LARAMIE COUNTY PLANNING & DEVELOPMENT DEPARTMENT

MEMORANDUM

TITLE: PUBLIC HEARING regarding a Subdivision Permit and Plat for Diamond

Hills, located in a portion of the NW1/4 NW1/4, Section 29, T.14N., R.60W.,

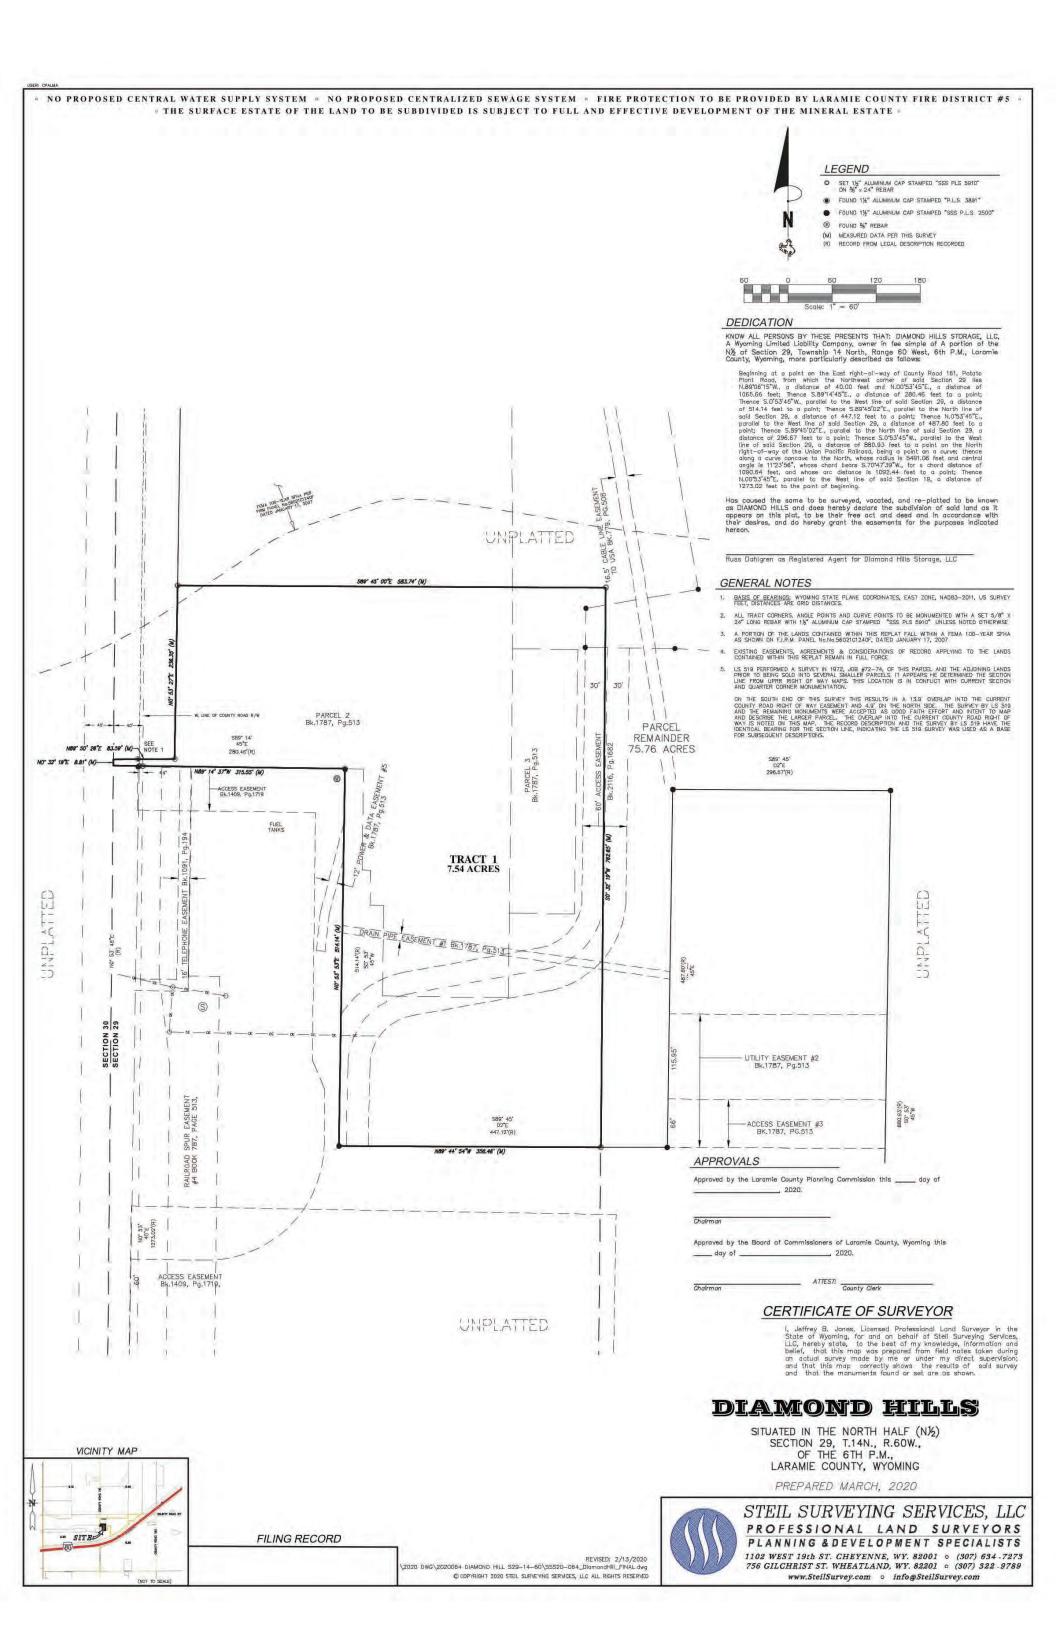
- 1. It would be helpful if CR 161 was labeled on the plat.
- 2. There are several line types shown that are not identified and it would be helpful if the legend included the line types.
- 3. I concur with the request for a waiver of a detailed Traffic Study and Drainage Study based on the information provided with the application.

- 1. It would be helpful to label the Point of Beginning and the tie to the Northwest corner of Section 29, with both being referenced in the legal description included in the DEDICATION. As currently shown on the plat, the bearings and distances called out in said legal description are a little confusing when they are placed next to the TRACT 1 boundary bearings and distances.
- 2. There are no State Plane Coordinates shown on the plat.
- 3. There is no "Statement to Vacate" shown on the plat. The DEDICATION states "Has caused the same to be surveyed, vacated and re-platted".
- 4. There are several instances where "the location of the recorded rights-of-way intersecting the boundary of the subdivision" are not shown.
- 12' POWER AND DATA EASEMENT EASEMENT #5, BK 1787, PG 513 DRAIN PIPE EASEMENT #1, BK 1787, PG 513

ACCESS EASEMENT, BK 1409, PG 1719 (??)

Need notary statement for Diamond Hills Storage LLC.

In the title block add PTN... Situaten in a Portion of the North Half...

- 1. The legal description, stated in both the Dedication and the title should be updated from the north half to include quarter quarters, to read "Situated in the NW1/4 NW1/4, Section 29, T.14N., R.60W., of the 6th P.M., Laramie County, WY.
- 2. The letter 'A' is capitalized unnecessarily several times in the Dedication, please correct.
- 3. The plat states that the it was prepared March, 2020, however the Revised date states 2/13/2020. This will need to be updated as the revision date cannot take place before the preparation date.

- 4. The Dedication states "Right-oi-way", please correct.
- 5. As this is a Subdivision Permit & Plat, rather than an Administrative Plat the signature blocks for the Planning Director and the Public Works Director need to be removed and spaces for the Planning Commission Chairman and the Board of County Commissioners Chairman added. These blocks must be directly adjacent to the right or bottom border of the plat. There also needs to be a signature block for the County Clerk added.

- 6. A statement must be added to the plat indicating the type of sewage disposal, the type of water supply, and the type of fire protection proposed for the subdivision.

- 7. Because Potato Plant Road is not an official county road, it should be removed from all language on the plat.
- 8. In the Dedication the number 19 has been hand-corrected to 29, please correct.

- 9. The Filing Record box must be completely clear of any wording.
- 10. There is no Statement to Vacate on the plat. This must be titled and stated clearly on the plat.

- 11. The Railroad Spur Easement #4 state Book 787, Page 513. Should the book number be 1787 as all the other records are?
